DESIGN DS	DRAWN BY DS	DART AEROSPACE LTD VICTORIA INTERNATIONAL AIRPORT, CANADA	
CHECKED <i>[Signature]</i>	APPROVED <i>[Signature]</i>	DRAWING NO. DEO 9095	REV. A SHEET 1 OF 1
DATE 97.10.29		TITLE 206 SADDLE GROOVE CHANGE	SCALE N75

## DART ENGINEERING ORDER

D2661	REV. B
D2662	REV. B
D2663	REV. B
D2664	REV. B
D2665	REV. B
D2666	REV. B
D2667	REV. B
D2668	REV. B

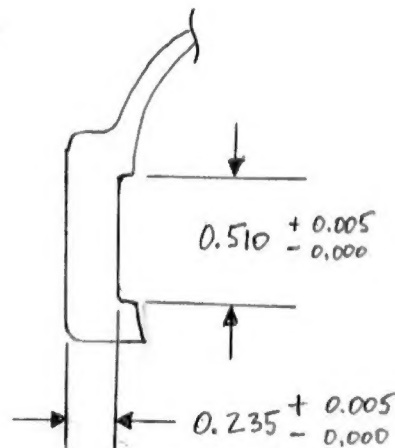
THE DIMENSION OF THE GROOVE THAT INTERLOCKS THE SADDLES  
ONTO THE SKIDTUBES SHOULD READ AS FOLLOWS:
